Work Order ID 166015

Item ID: D2731-7RG Accept *N900040100* Setup Start *NS1*
 Revision ID: Stop *NS2*
 Item Name: Mounting Lug
 Start Date: 9/7/2017 Start Qty: 24.00 *24* Cust Item ID:
 Required Date: 9/13/2017 Req'd Qty: 24.00 *24* Customer:
 Reference:

DRAWING NO. D2731	TITLE MOUNTING LUG	REV. C	DART AEROSPACE USA, INC ENGINEERING ORDER		D.E.O. NO. D2731-C-1	SHEET NO. SHEET 1 OF 1	SCALE NTS
DRAWN <i>q</i>	CHECKED <i>Sc</i>	MFG. APPR. <i>MA</i>	APPROVED <i>MD</i>		DE APPR. <i>MD</i>		
DATE 11.05.02	DATE 11.05.09	DATE 11.05.09	DATE 11.05.09		DATE 11.05.09

ADD D2731-xRG OPTION

SECTION A-A D4-2
SCALE 2X
R0.06 MIN-R0.10 MAX
2 PL

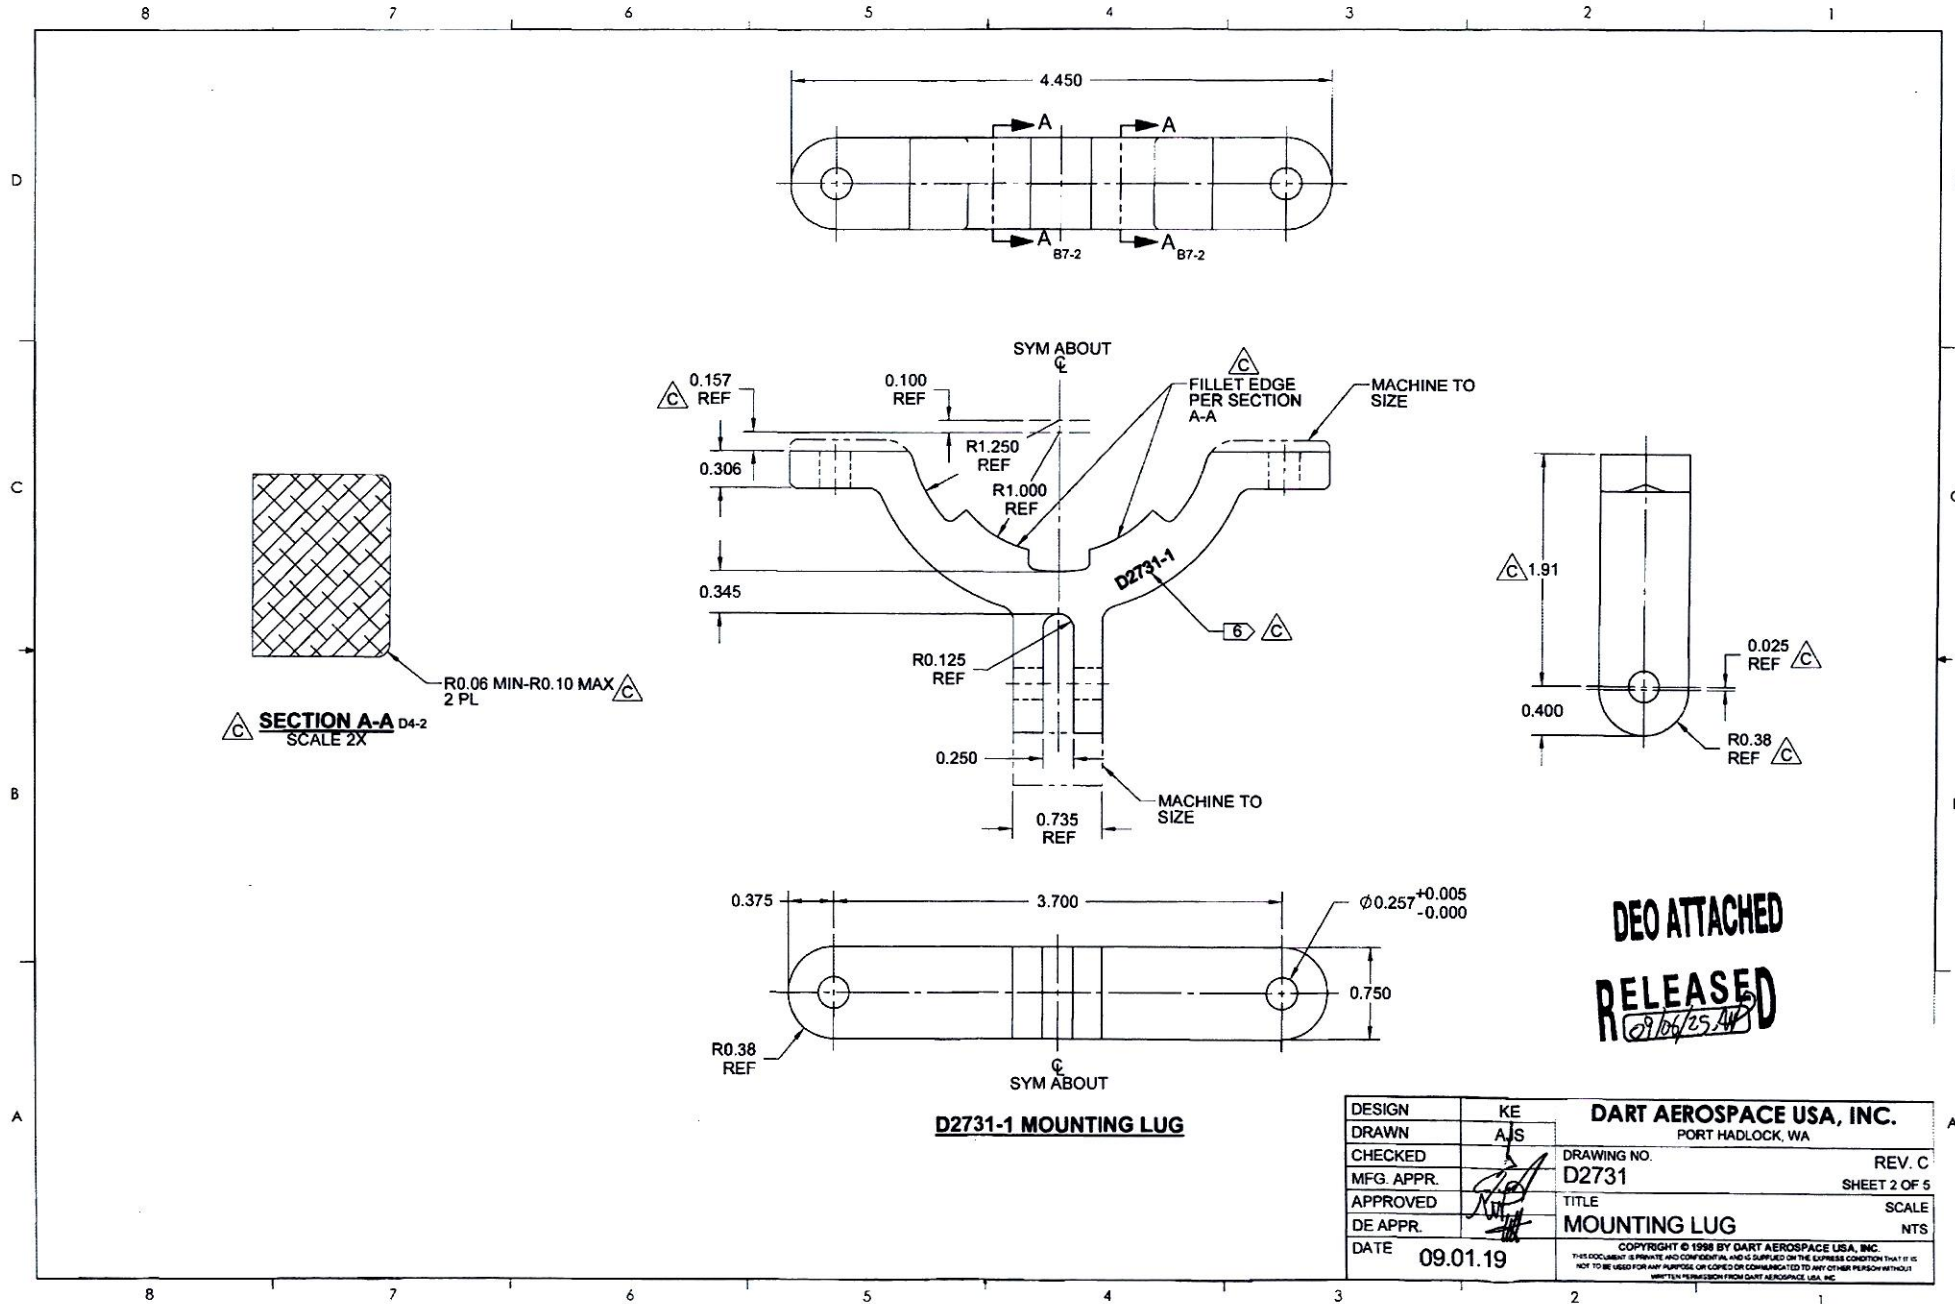
C	REDRAWN IN SOLIDWORKS TO CURRENT DESIGN STANDARDS. REFER TO SECTION A-A, B-B, C-C & D-D FILLET ADDED TO PREVENT CHAFING OF RUBBER CUSHION ON INSTALLATION.	AJS	09.01.19
B	REVISED DIMENSIONS	KE	99.07.06
A	NEW ISSUE	KE	98.05.13
REV.	DESCRIPTION	BY	DATE
DESIGN	KE	DART AEROSPACE USA, INC. PORT HADLOCK, WA	
DRAWN	AJS		
CHECKED		DRAWING NO.	REV. C
MFG. APPR.		D2731	SHEET 1 OF 5
APPROVED		TITLE	SCALE
DE APPR.		MOUNTING LUG	NTS
DATE	09.01.19	COPYRIGHT © 1999 BY DART AEROSPACE USA, INC. THIS DOCUMENT IS PRIVATE AND CONFIDENTIAL AND IS SUPPLIED ON THE EXPRESS CONDITION THAT IT IS NOT TO BE USED FOR ANY PURPOSE OR COPIED OR COMMUNICATED TO ANY OTHER PERSON WITHOUT WRITTEN PERMISSION FROM DART AEROSPACE USA, INC.

D2731-1RG MOUNTING LUG (SHOWN)
D2731-3RG/-5RG/-7RG MOUNTING LUGS (SIMILAR)

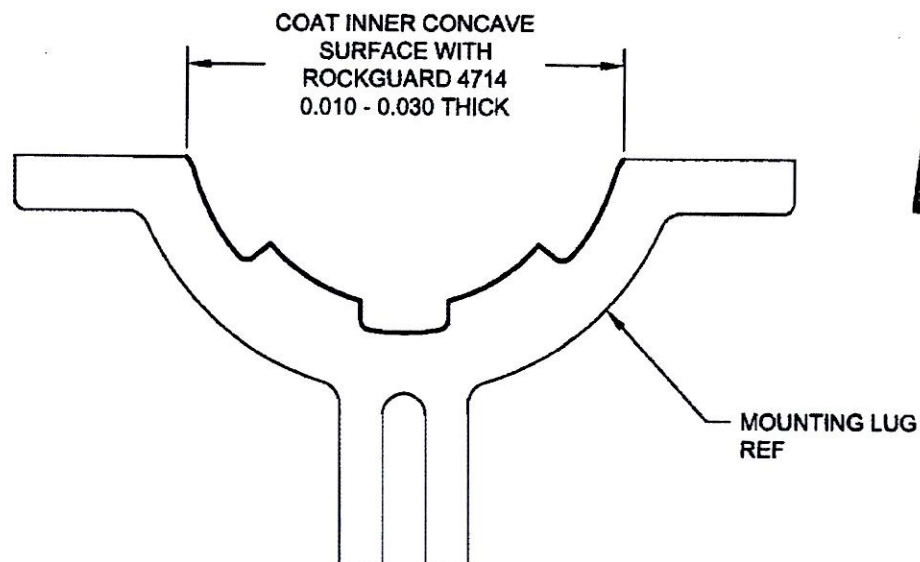
D2731-xRG MOUNTING LUGS ARE INDENTICAL TO D2731-x MOUNTING LUGS, HOWEVER AFTER FINISH, COAT INNER CONCAVE SURFACE WITH "PLUS ONE ROCKGUARD 4714" AS SHOWN BELOW.
